UNITED STATES  
NUCLEAR REGULATORY COMMISSION  
WASHINGTON, D. C. 20585

Re: Transcript of 6/17/85 Feedback Interview

QUALITY ASSURANCE DEPARTMENT  
NONCONFORMANCE REPORT (NCR)

(1) NCR No. M-1802

SERIAL NO. N° 5091

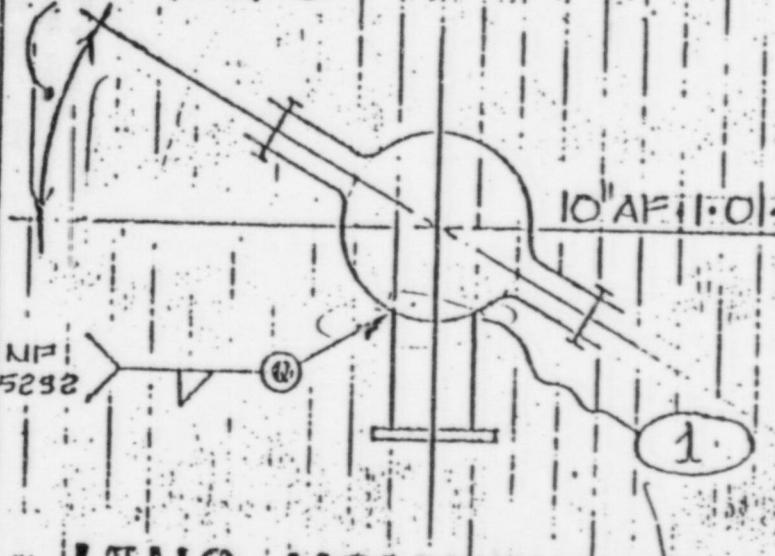
ADD   
CHANGE THE WELD  
ATTACHING THE  
CLAMP TO THE  
STANCHION FROM  
A SHOP WELD  
TO A FIELD  
WELD.

8417

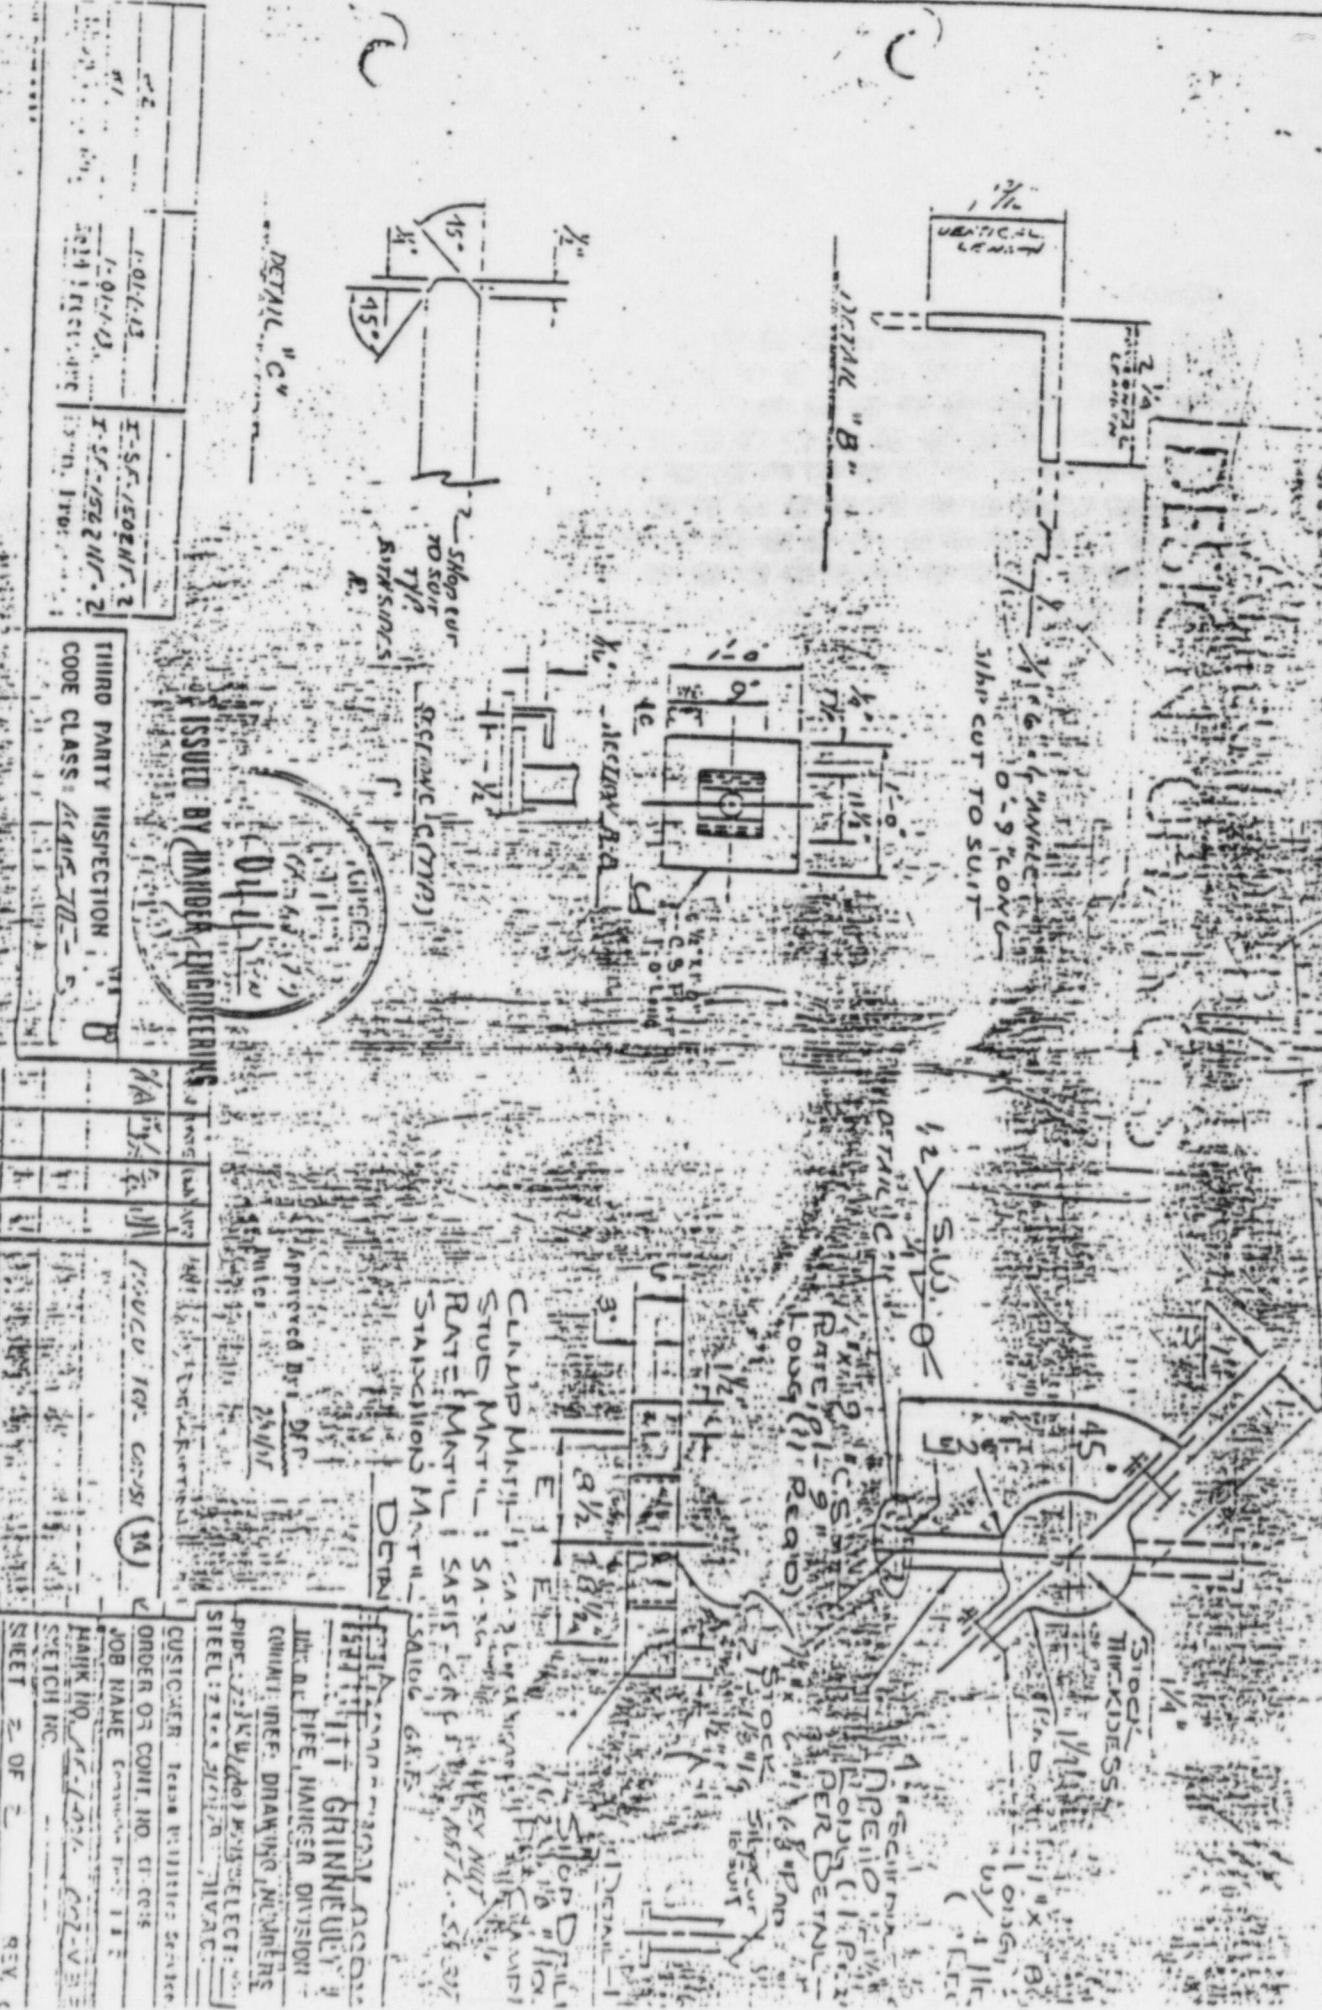
- B. Item #11 has been added on the bill of materials per ABRF 000315. ABRFs cannot be used to add or delete item numbers.
  - C. CMC 8417 R2, 10-3-79, Instruction 5, removed item 7 and added items 9 & 10. Item 7 was QC verified on 9-26-79 per ABRF 00072 and 73. Weld 2 & 3 were made on 10-18-79 using plates called out on ABRFs 00072 & 73. CMC 8417 required removal of item 7 and replaced with items 9 & 10. This was not accomplished and items 9 & 10 were not fabricated. Craft personnel failed to follow design changes as per CMC 8417.

REASON FOR CHANGE: **AVOID REBAK**

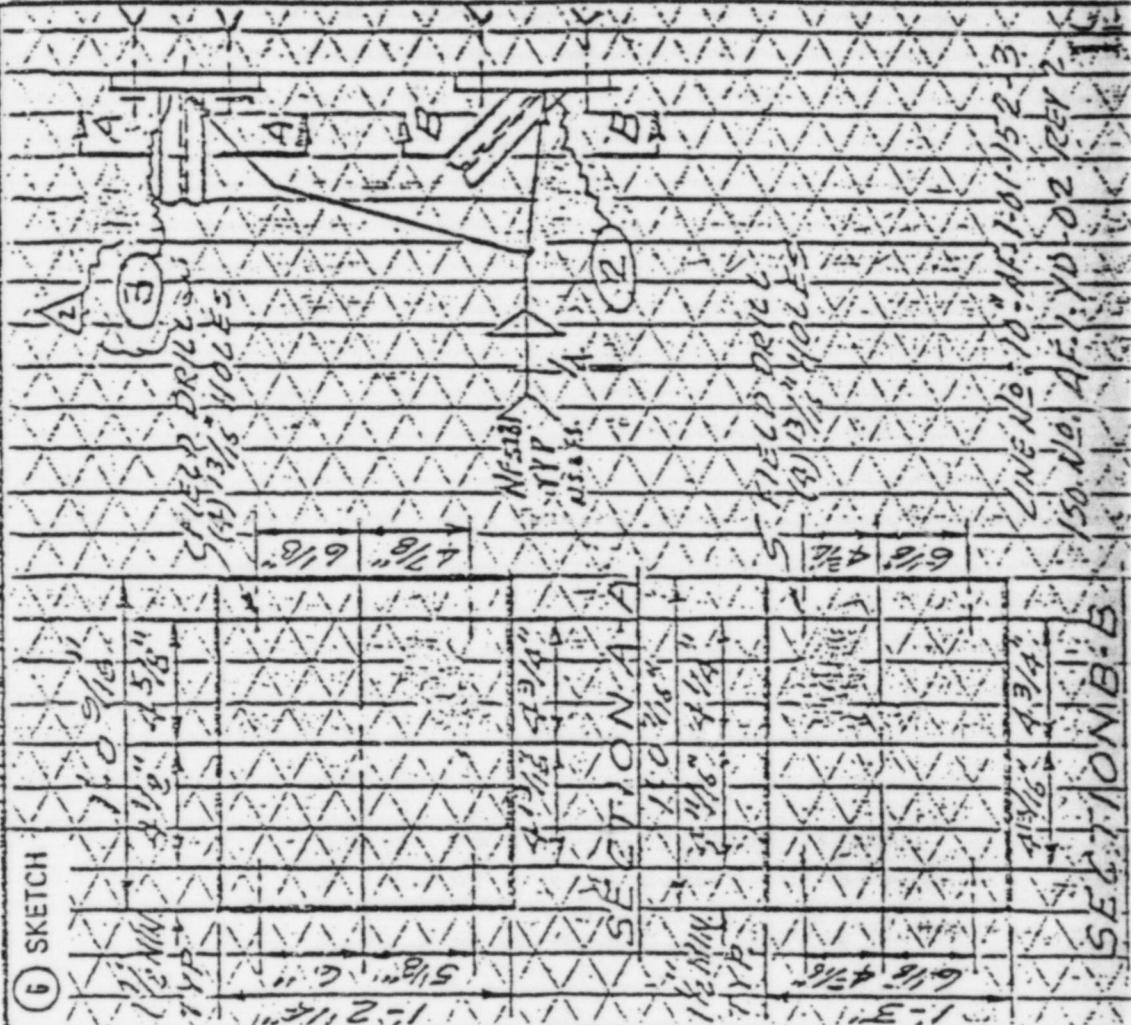
- B. Item #11 has been added on the bill of materials per ABRF 000315. ABRF's cannot be used to add or delete item numbers.
- C. CMC 8417 R2, 10-3-79, Instruction 5, removed item 7 and added items 9 & 10. Item 7 was QC verified on 9-26-79 per ABRF 00072 and 73. Weld 2 & 3 were made on 10-18-79 using plates called out on ABRF's 00072 & 73. CMC 8417 required removal of item 7 and replaced with items 9 & 10. This was not accomplished and items 9 & 10 were not fabricated. Craft personnel failed to follow design changes as per CMC 8417.

- IB. Item 11 was added to the bill of material by the craft traveler dept. via an ABRF; this is not per procedure; personnel have been instructed to discontinue this practice and follow procedure.
